PCN-2014-548

**Assembly and Test Site Transfer from StatsChipPac Kuala Lumpur, Malaysia (SCM)
to ASE-Chung Li (ASE-CL) Taiwan for the CS42L56-CNZ(R) component**

**Process/Product Change Notification
(Reference Advance PCN-2014-533)**

Mark format: **234**

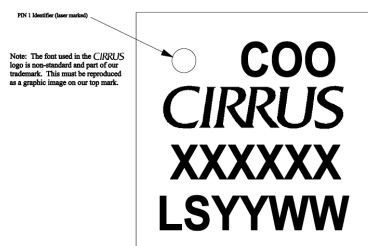
Mark change:

- Assembly vendor = None (not shown on mark)
- COO = changing From: **MYS** → TO: **TWN**

With the Assembly Site and Test Transfer to ASE-Chung Li (ASE-CL) Taiwan, the material will receive the appropriate designation for the Country Of Origin.
